**RE: Comments, Draft Focused Feasibility Report  
Metal Bank of America Superfund Site**

Attached are our comments on the Draft Focused Feasibility Report prepared by CDM and issued 17 May 2000.

Figure 2.1. Schematic Diagram of Release Pathways for PCB Dig and Haul Remediation.

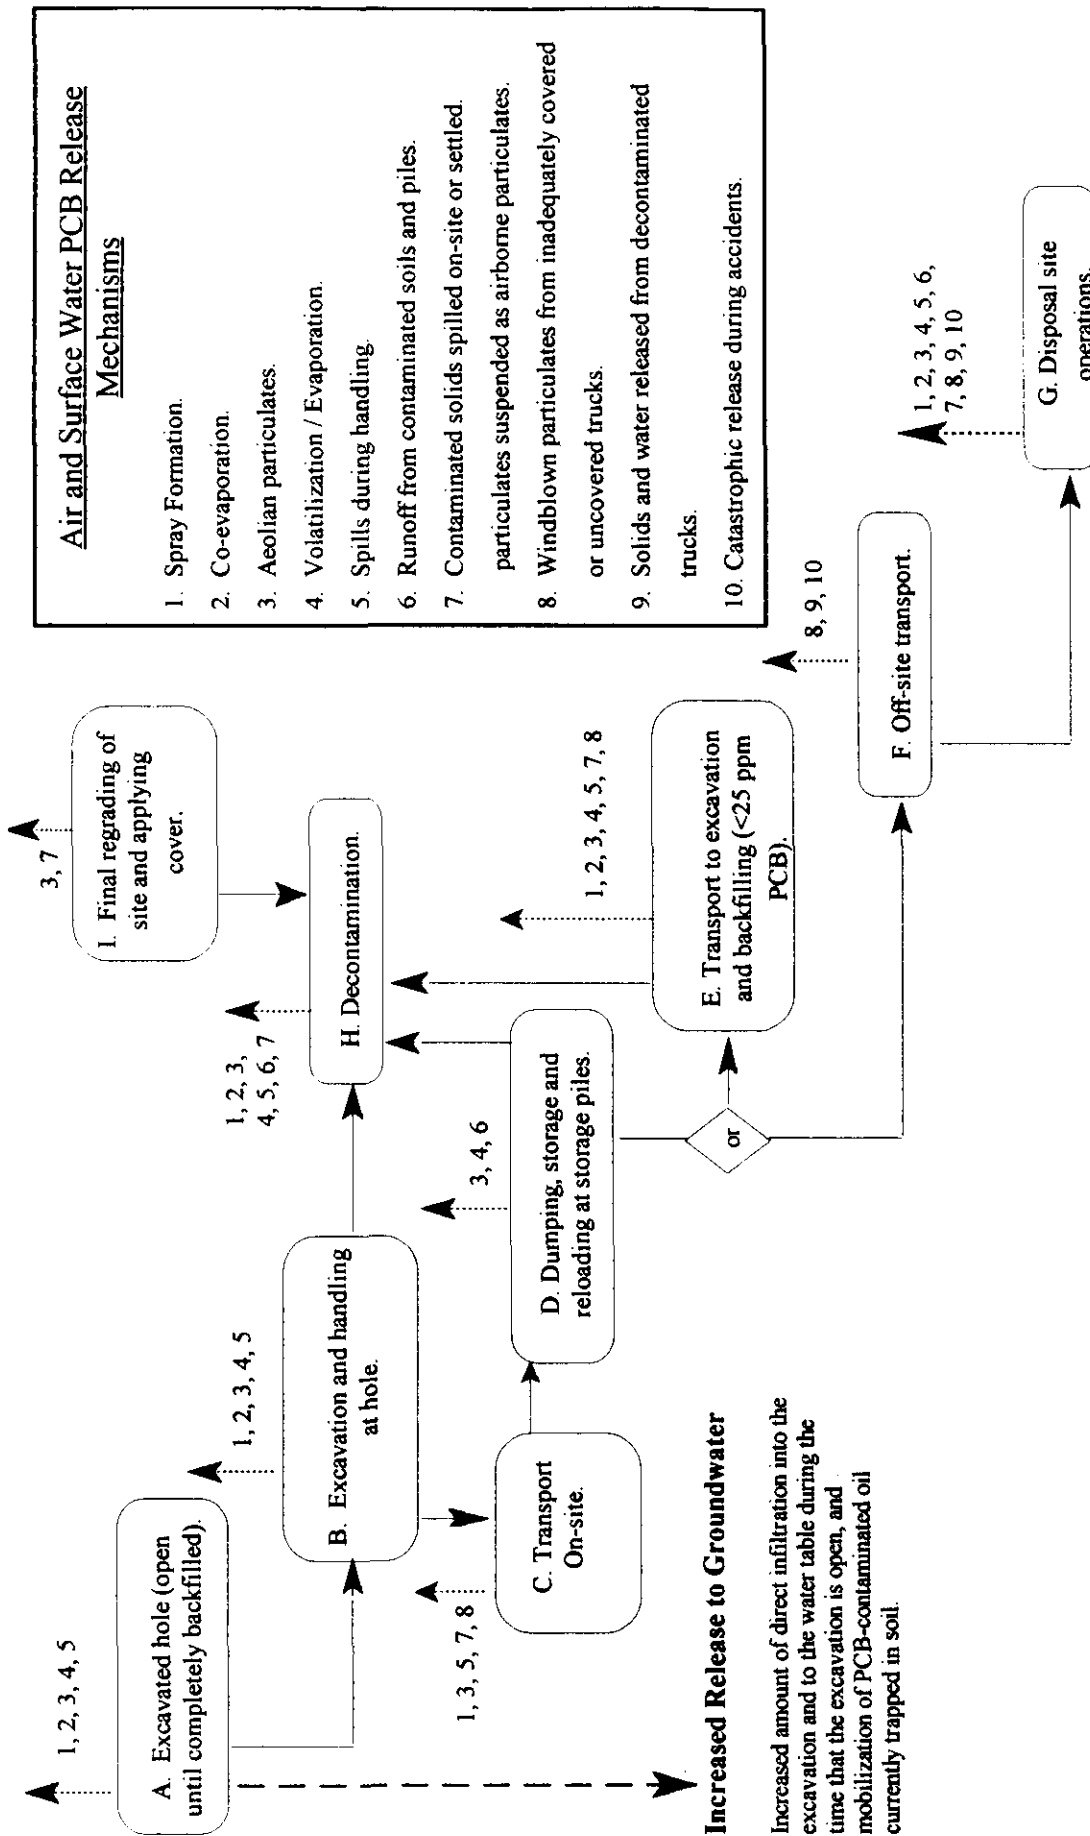
Figure 2.1 is a schematic diagram which summarizes the information relating to releases of PCBs<sup>25</sup> caused by dig and haul remediation at the Site, their locations, mechanisms, and pathways.

As can be seen in Figure 2.1 each unit operation during remediation at the Site has PCB releases associated with it. These operations are connected by a flow of material. Each operation has been designated by a letter as illustrated in Figure 2.1.

- b.) The dig and haul options depend on a large number of steps (See Figure 2.1) to accomplish. There will be a large number of trucks and equipment moving back and forth on-site, and hauling material from and to the Site. This will require a great deal of coordination and communication to ensure smooth operations, again creating difficulties in implementing these options.

**Figure 2.2. Post-Remediation Release Pathways.**

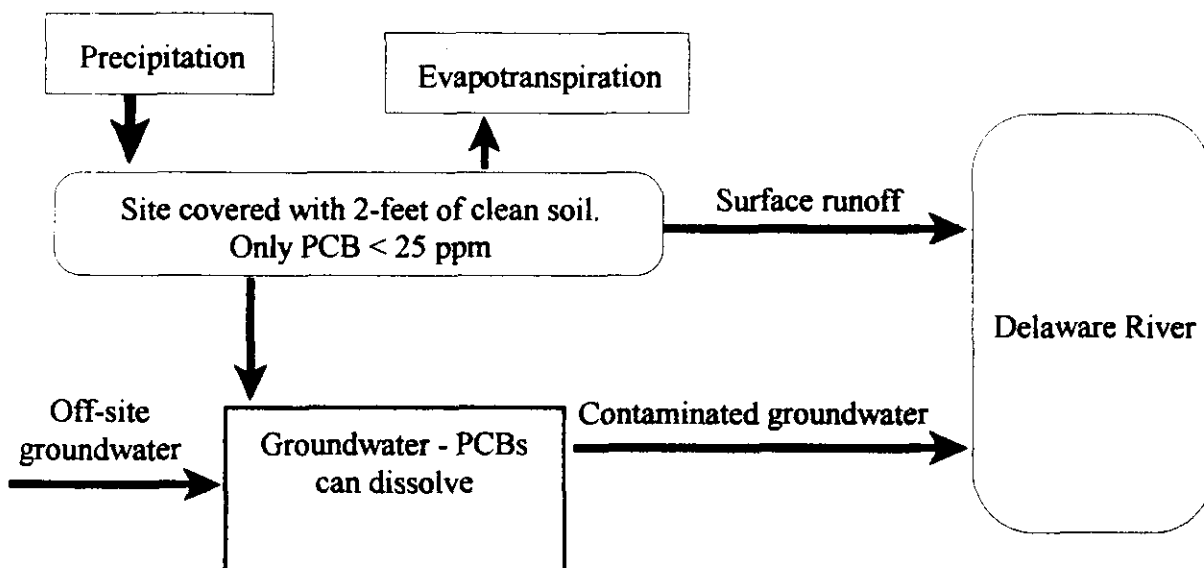
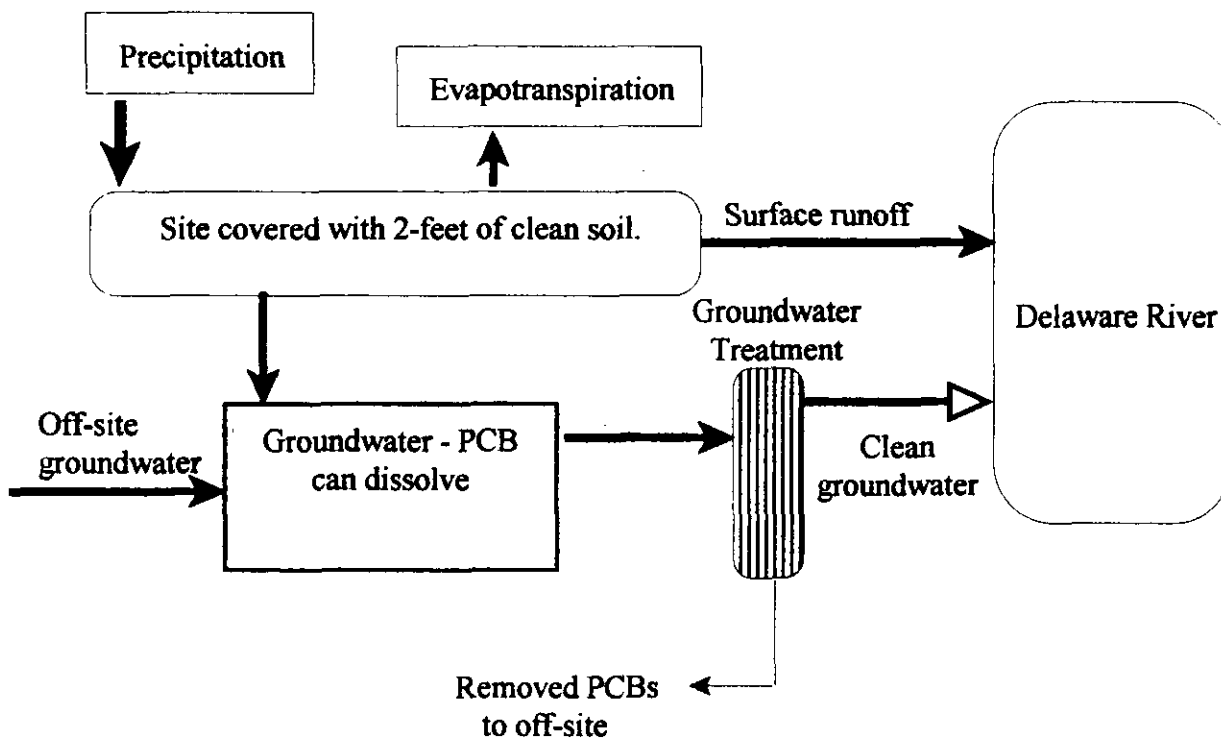
Figure 2.2 illustrates the differences in post-remediation environmental releases of PCBs between the dig and haul and the secure and treat plans.
